THE POINTE AT WOLF CREEK
LOCATED IN THE SOUTHWEST QUARTER OF SECTION 22,
TOWNSHIP 7 NORTH, RANGE 1 EAST, SALT LAKE BASE AND MERIDIAN,
WEBER COUNTY, UTAH
JUNE 2021

Please see comment on second page. Address review will be submitted once I get clarification on how the unit numbering works.

UPPER LEVEL FLOOR PLAN

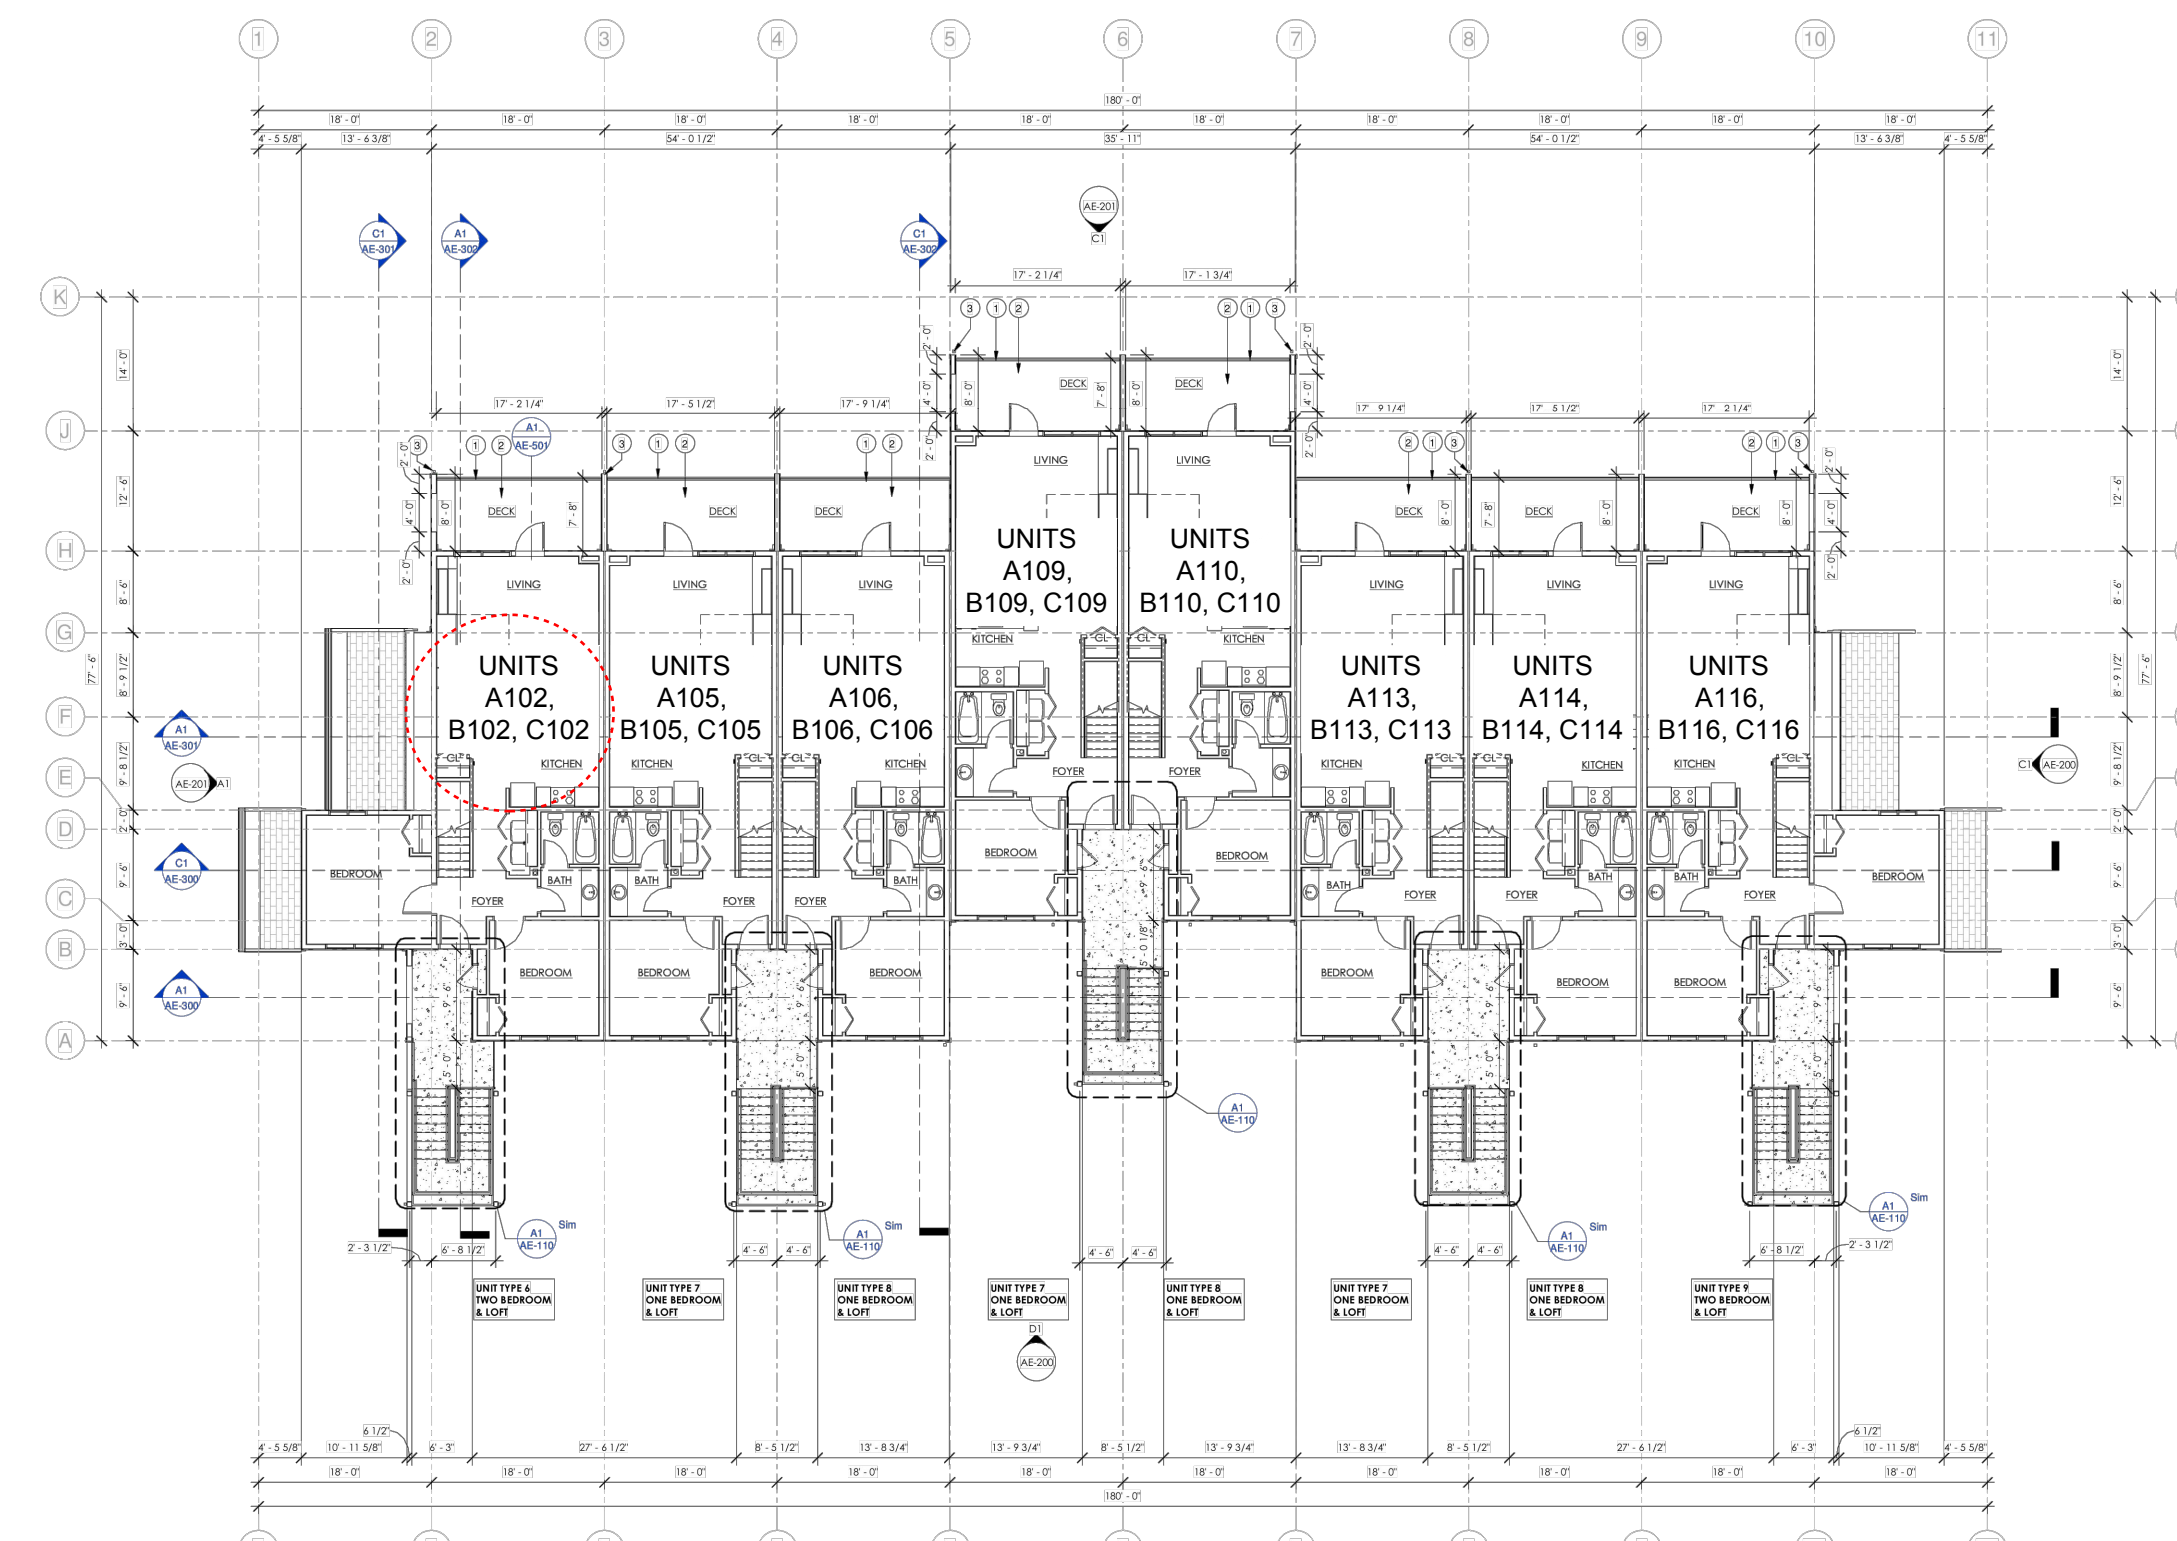
How does the numbering work? Each unit should be the same number.
